Project Name: Lauderdale Beach Hotel Case #: 51-R-01

DRC SITE PLAN REVIEW AND COMMENT REPORT

LAUDERDALE BEACH HOTEL RADIO TEST POINTS

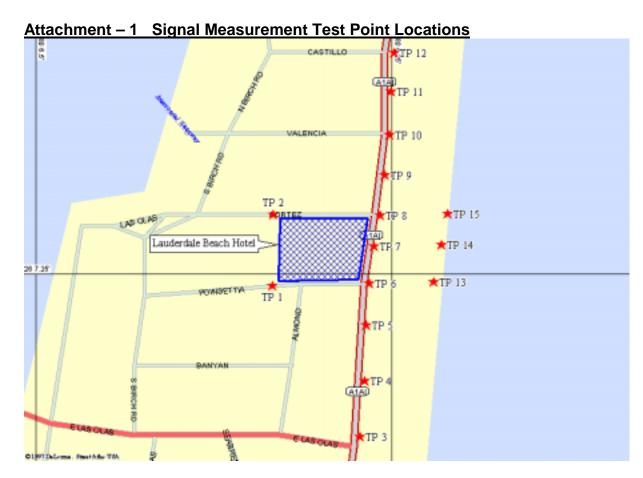
This site plan will adversely impact Public Safety radio communications in the future, specifically the beach along A1A from Valencia to Las Olas Blvd. It is the developer's responsibility to contract with Motorola or another qualified vendor to perform signal strength measurements. This measurement shall be in microvolts per meter converted to dBm. All equipment used shall have current certification traceable to the National Bureau of Standards. Copies of the certificates shall be submitted as a part of the documentation. The map in *Attachment – 1* indicates the locations to be used for the measurements. GPS may be utilized to correlate exact location to the reading value to facilitate future measurements. All equipment used in the first test shall be utilized in all subsequent tests to insure accuracy and consistency in the comparison of the data. Tests shall be performed using a ¼ wave antenna mounted on a suitable ground plane held 1.5 meters above ground.

TP 1 at the southwest corner of the structure – 1 meter from structure wall TP 1 at the northwest corner of the structure – 1 meter from structure wall

TP 3 – TP 12 on the Beachwall (seaward side of A1A) TP 13 –TP 15 at the high water mark on the beach.

All measurements at 1.5 meters above ground level Page 2 of 3

City Staff recommends that the developer contact Steve Wurster at Motorola to arrange for this testing. Steve's telephone number is (954) 723-8927. Motorola's field engineering staff is familiar with the required equipment and has provided similar testing services in the past.
